**Re: New Office/ Warehouse Facility**  
**8401 Firestone Lane NE**  
**Traffic Circulation Layout**  
Architect's Stamp 05-05-23 (C17-D013B3)

Based upon the information provided in your submittal received 05-08-23, the above referenced plan cannot be approved for Building Permit until the following comments are addressed:

1 SITE PLAN  
2 SCALE 1"=20'

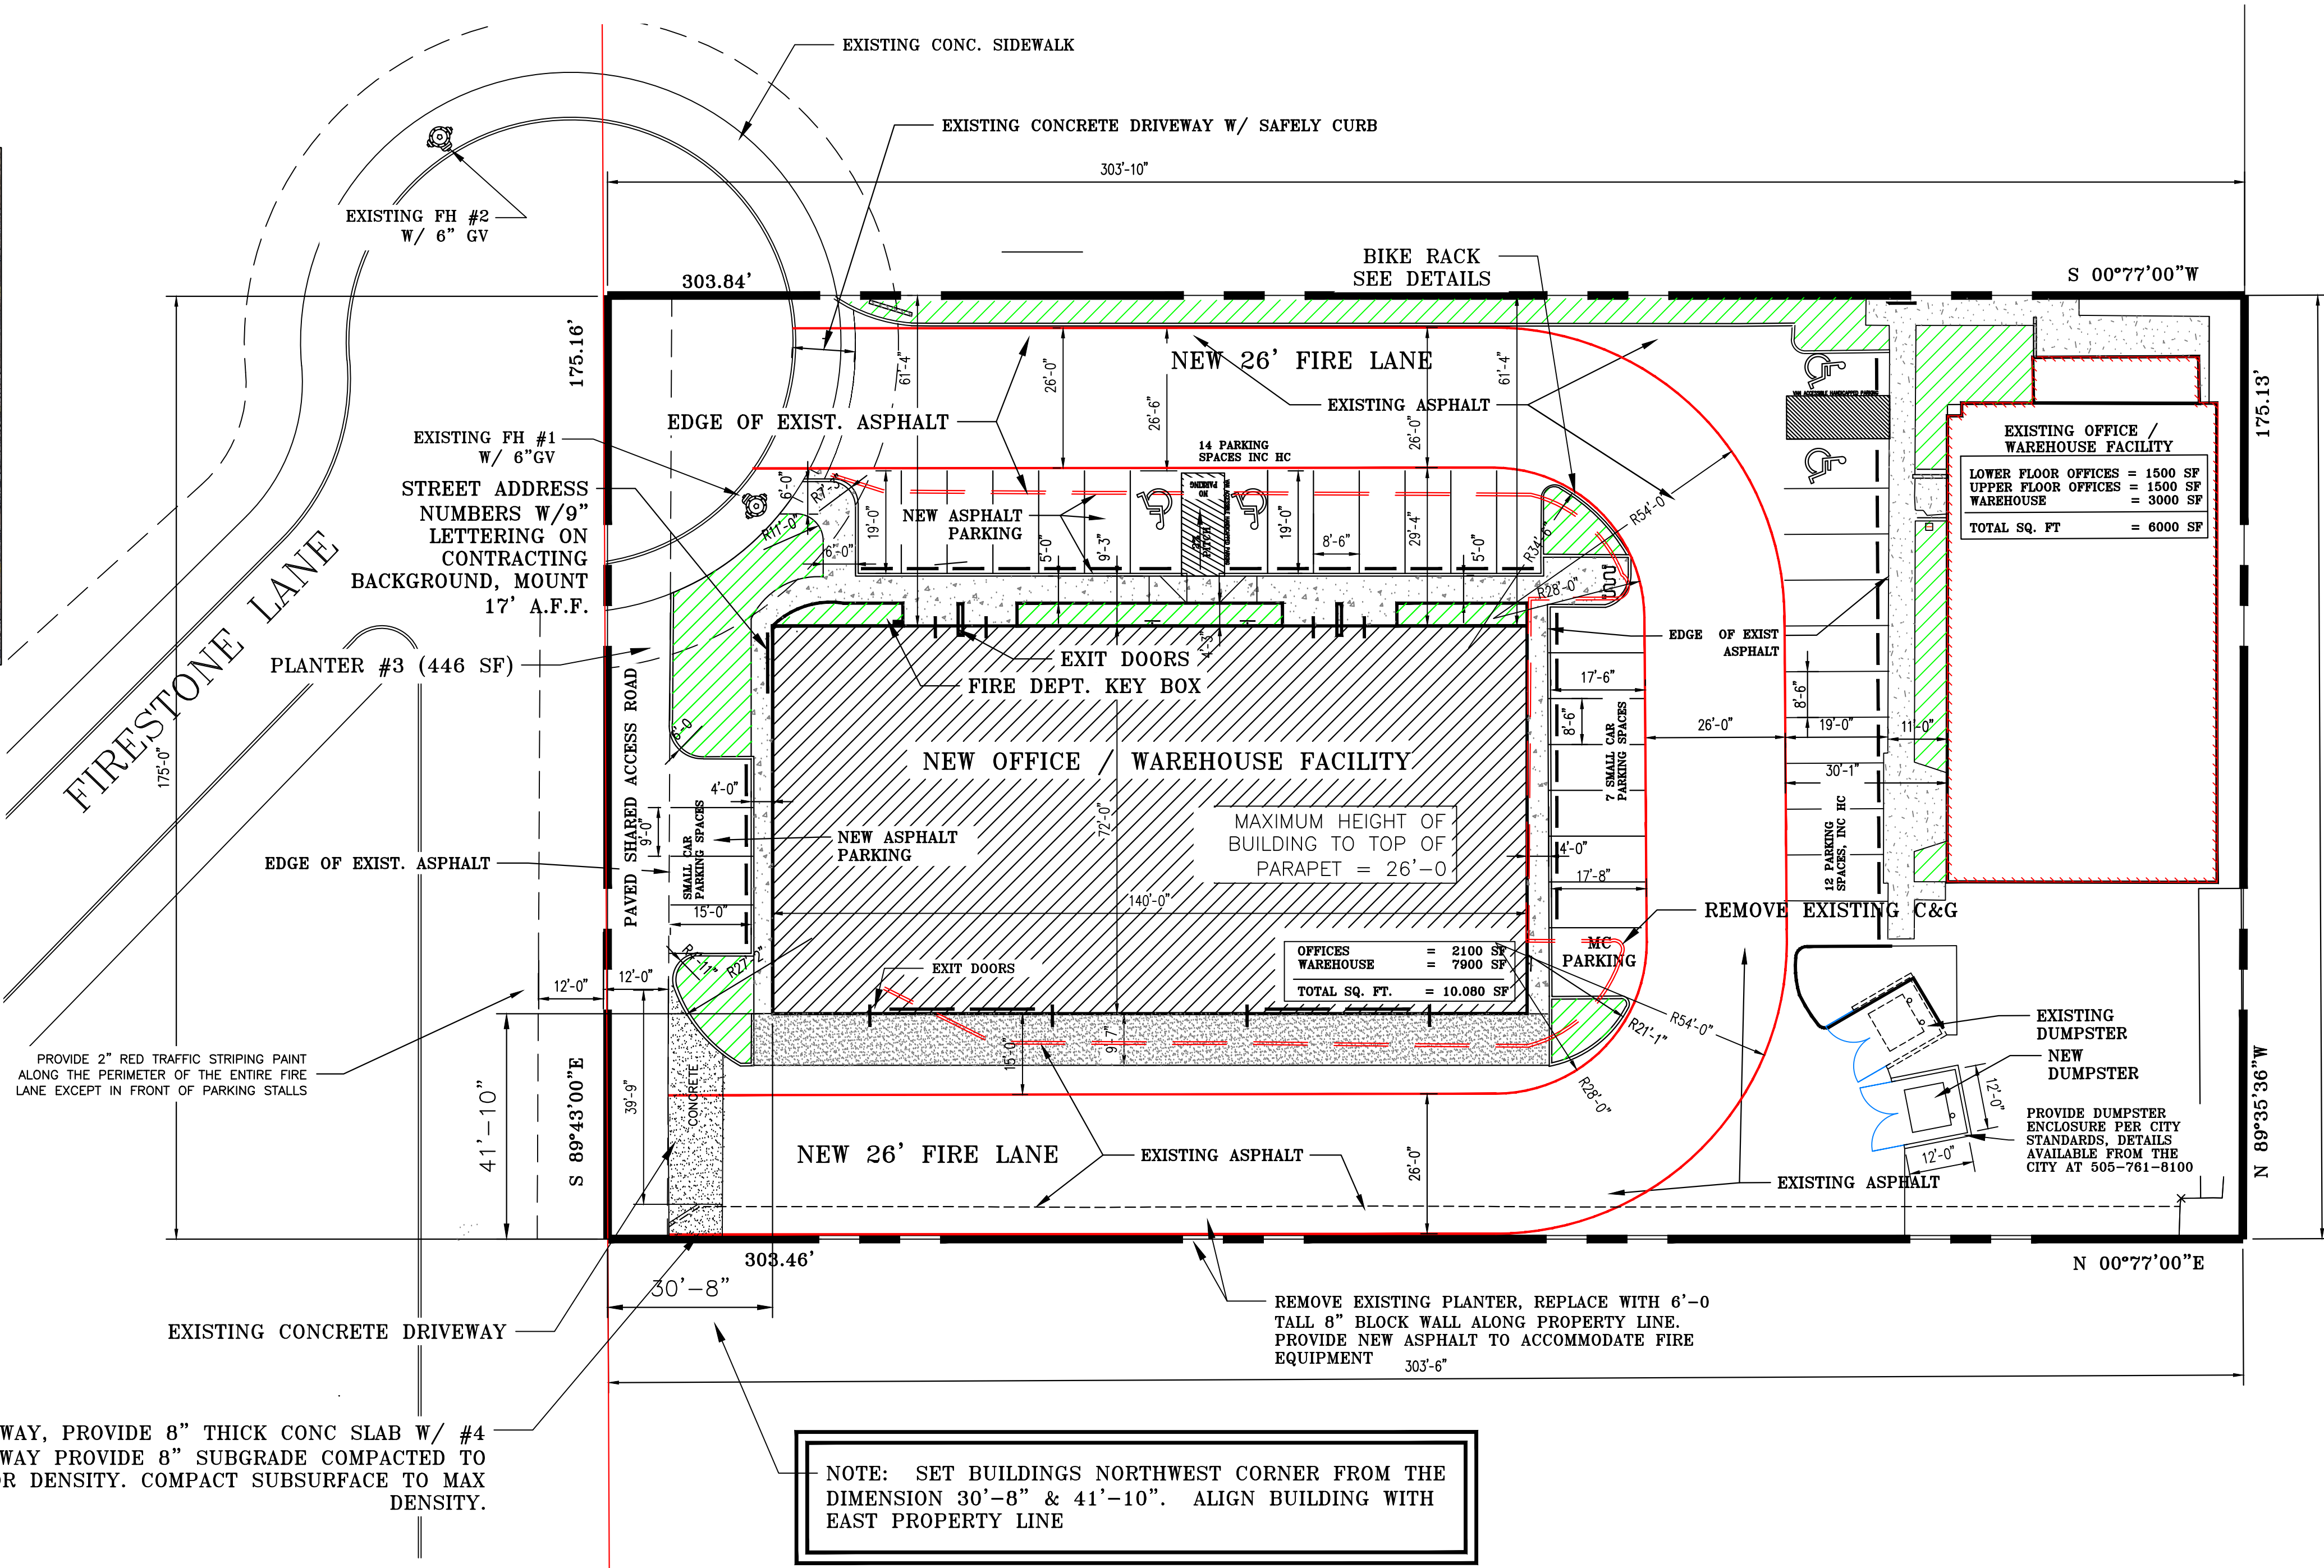
1. Identify all existing access easements and rights of way width dimensions.
2. Identify the right of way width, medians, curb cuts, and street widths on Firestone Lane.
3. Provide site access width.
4. Shared Site access: driveways that straddle property lines, or are entirely on one property but are to be used by another property, shall have an access easement. Please include a copy of your shared access agreement with the adjacent property owner.
5. Provide sidewalk easement. For sidewalk easement, please contact Carrie Mouck at (505)-924-3996, [camouck@cabq.gov](mailto:camouck@cabq.gov)

7. Label the compact parking spaces by placing the words “**COMPACT**” on the pavement of each space.
8. Please update the existing ADA parking spaces to the current standard.

9. Please provide details for the proposed interior ADA ramps.
10. All bicycle racks shall be designed according to the following guidelines:
  - a. The rack shall be a minimum 30 inches tall and 18 inches wide.

13. Bicycle parking spaces shall be at least 6 feet long and 2 feet wide.
14. Per DPM, a 6 ft. wide ADA accessible pedestrian pathway is required from the ADA parking stall access aisles to the building entrances. Please clearly show this pathway and provide details.

15. Please provide a copy of Solid Waste and Fire Marshal approval.
16. Show the clear sight triangle and add the following note to the plan: “Landscaping and signage will not interfere with clear sight requirements. Therefore, signs, walls, trees, and shrubbery between 3 and 8 feet tall (as measured from the gutter pan) will not be acceptable in the clear sight triangle.

17. Please specify the City Standard Drawing Number when applicable.
18. Add a note stating “All broken or cracked sidewalk must be replaced with sidewalk and curb & gutter.” A build note must be provided referring to the appropriate City Standard drawing.

B.1 BIKE RACK  
NO SCALE

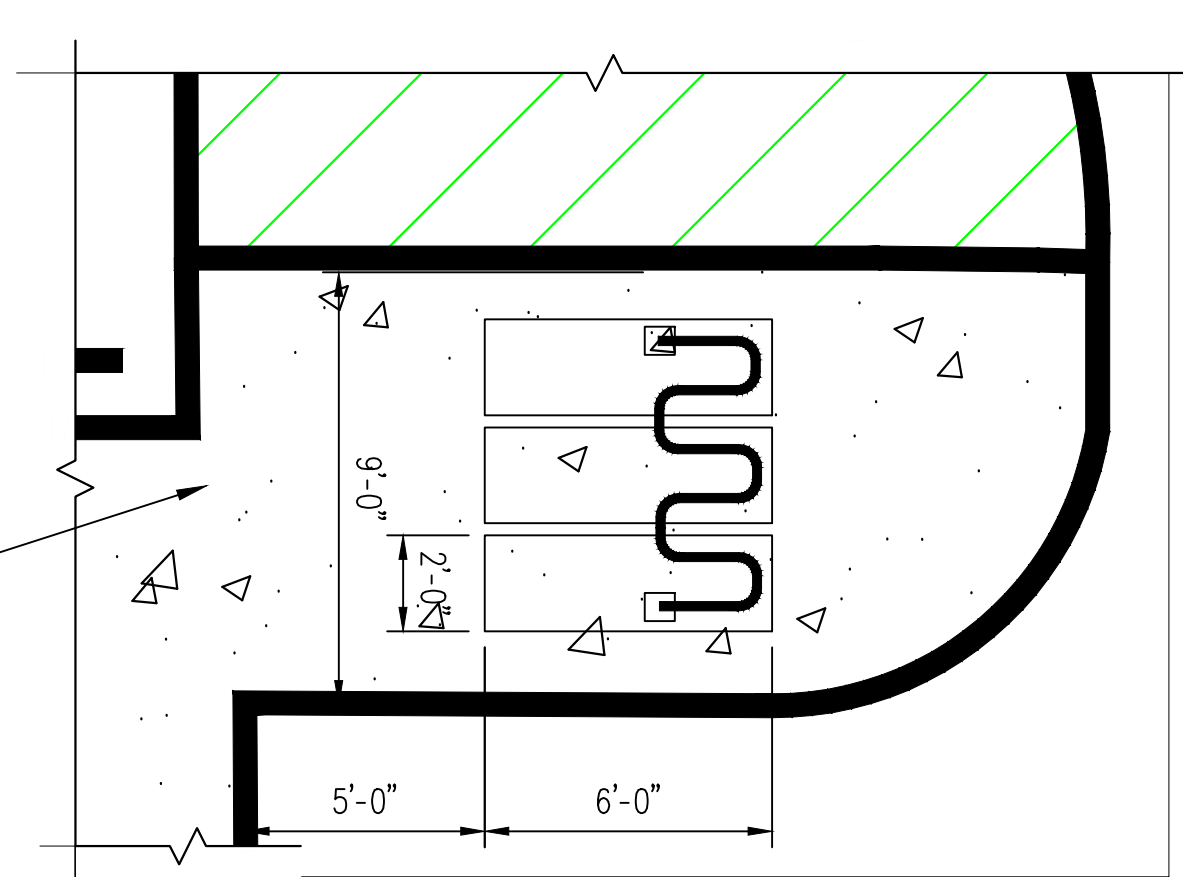
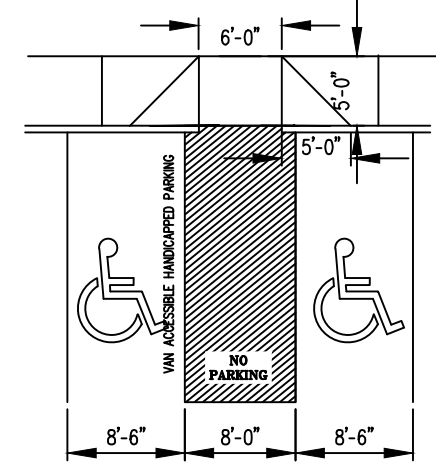
- b. The bicycle frame shall be supported horizontally at two or more places. Comb/toaster racks are not allowed.
  - c. The rack shall be designed to support the bicycle in an upright position. See the IDO for additional information.

- d. The rack allows varying bicycle frame sizes and styles to be attached.
  - e. The user is not required to lift the bicycle onto the bicycle rack.

- f. Each bicycle parking space is accessible without moving another bicycle.
11. Bicycle racks shall be sturdy and anchored to a concrete pad.
12. A 1-foot clear zone around the bicycle parking stall shall be provided.

1 PARKING LOT LAYOUT PLAN

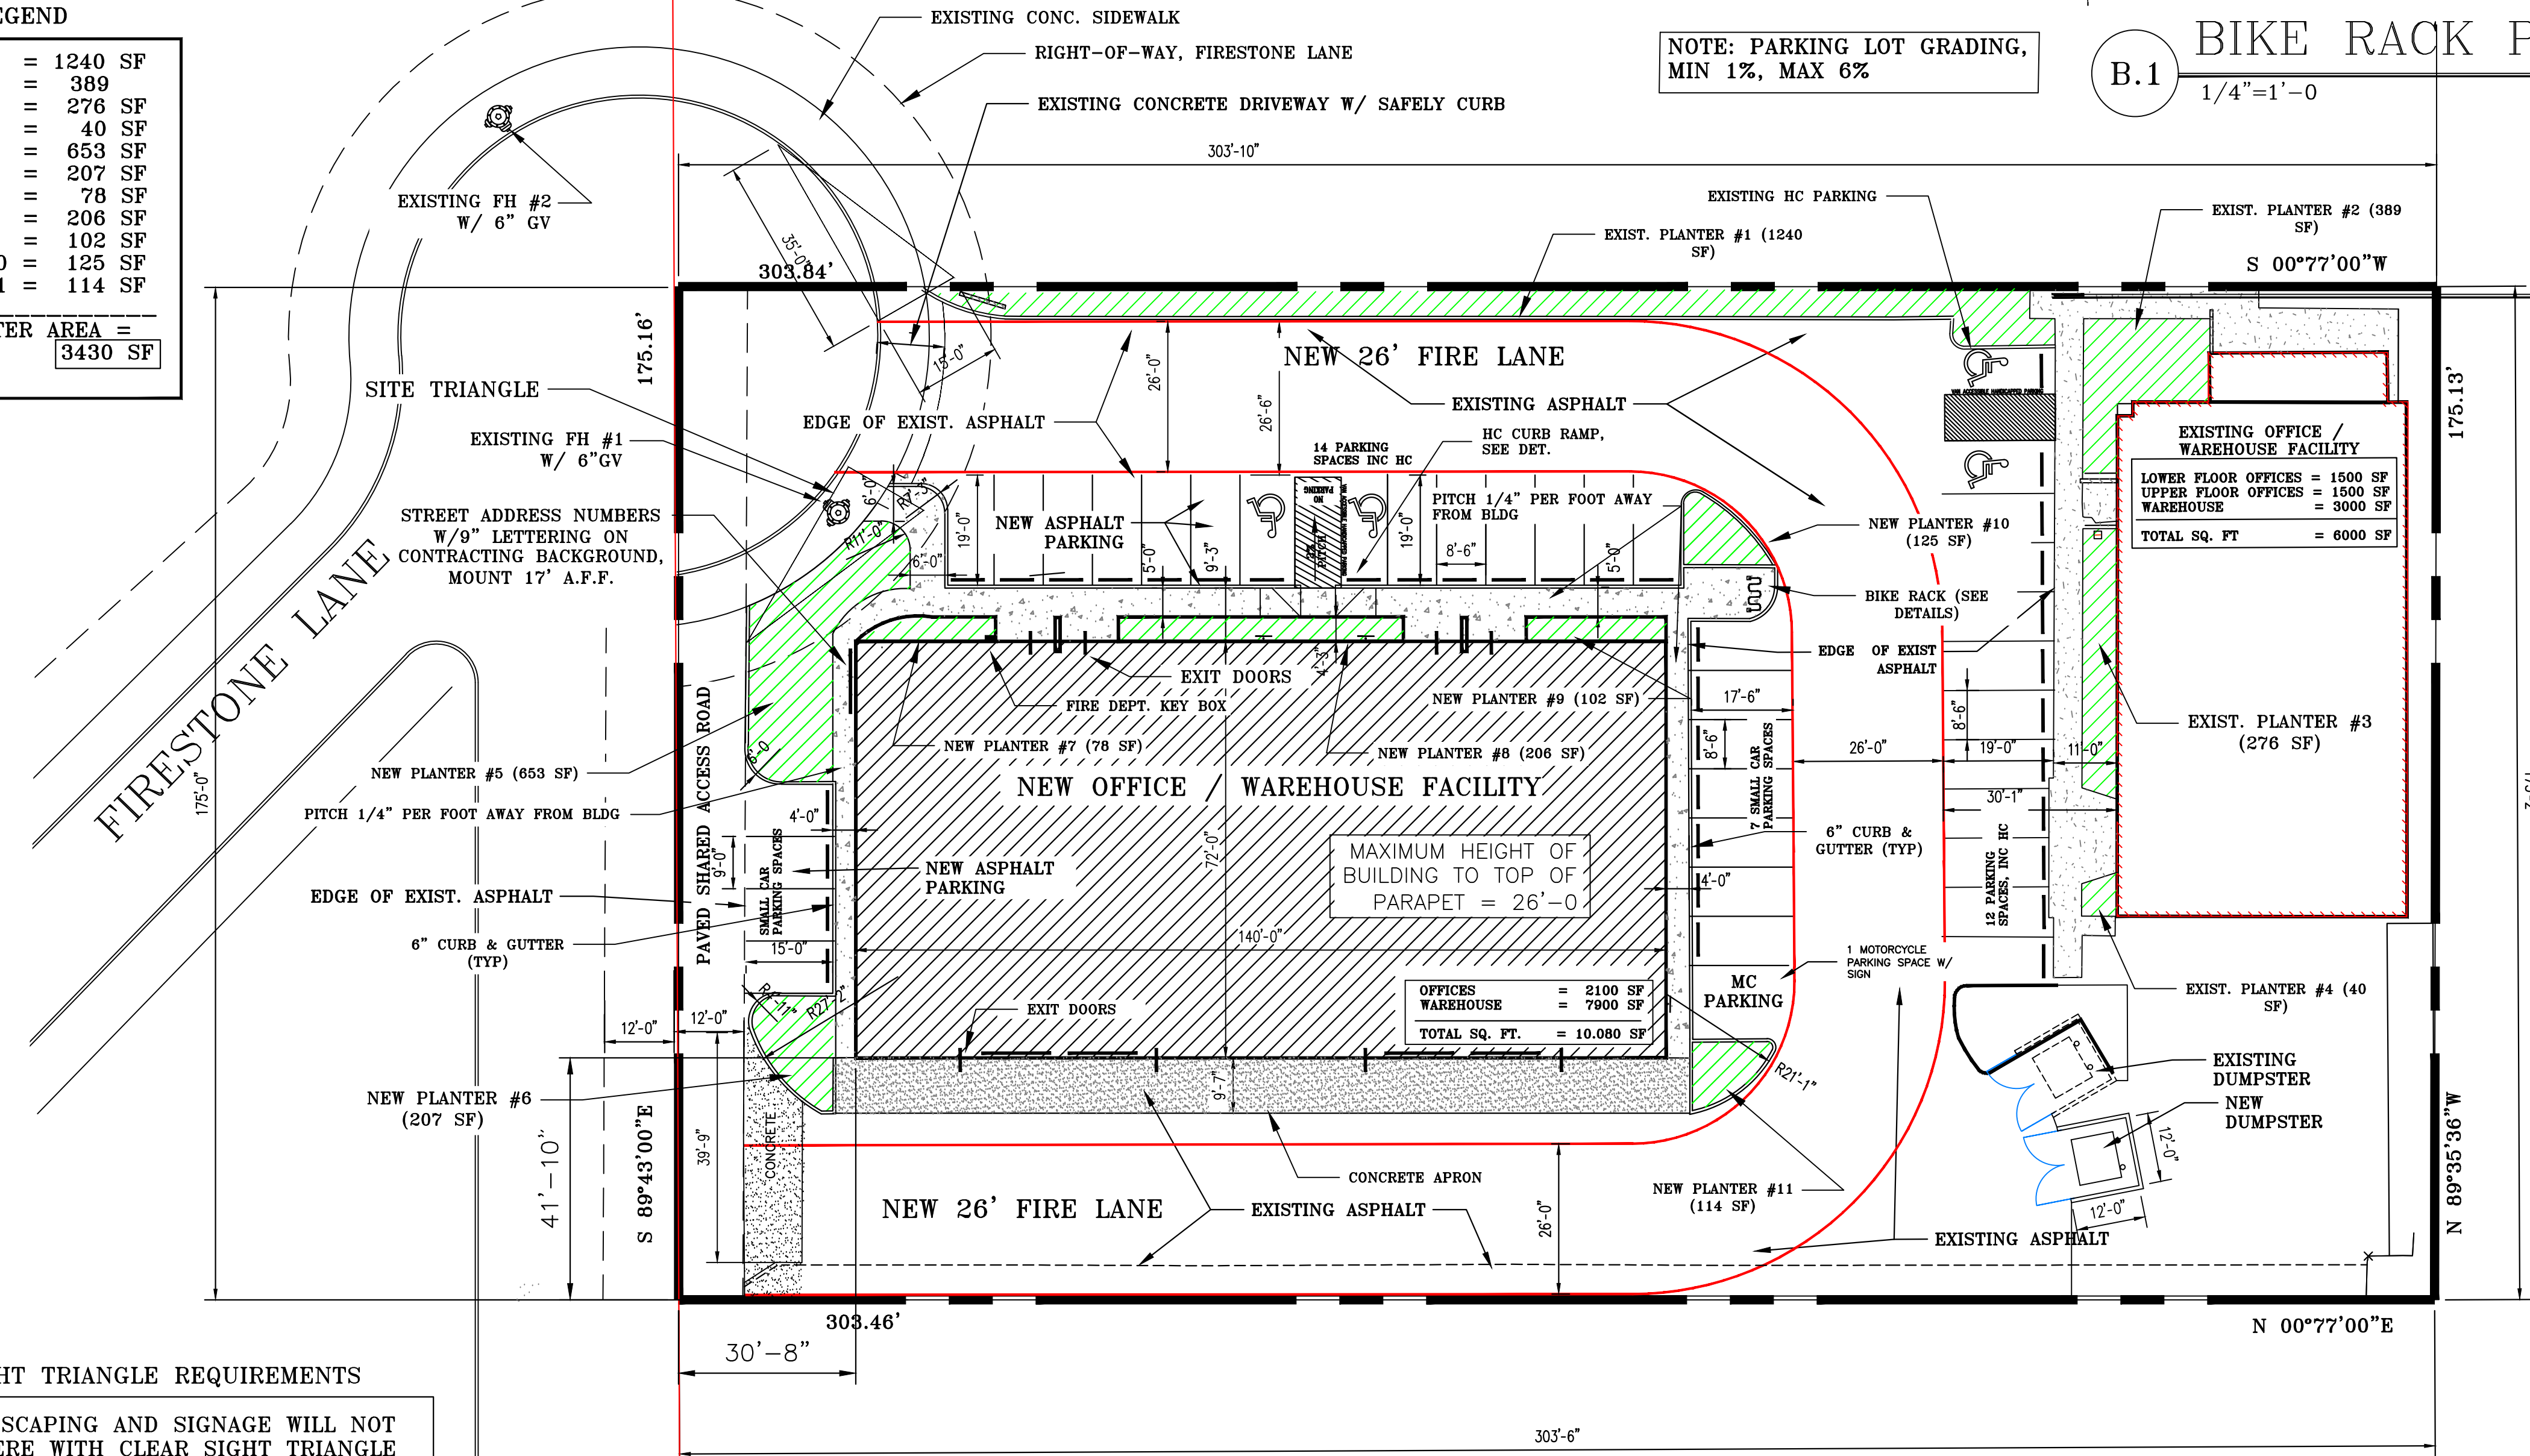
6. The minimum parking stall dimensions are:

Type of parking	Min. Width	Min. Length	Min. Overhang
Standard	8.5'	18'	2'
Compact	7.5'	15'	1.5'
Motorcycle	4'	8'	N/A
ADA	8.5'	18'	2'
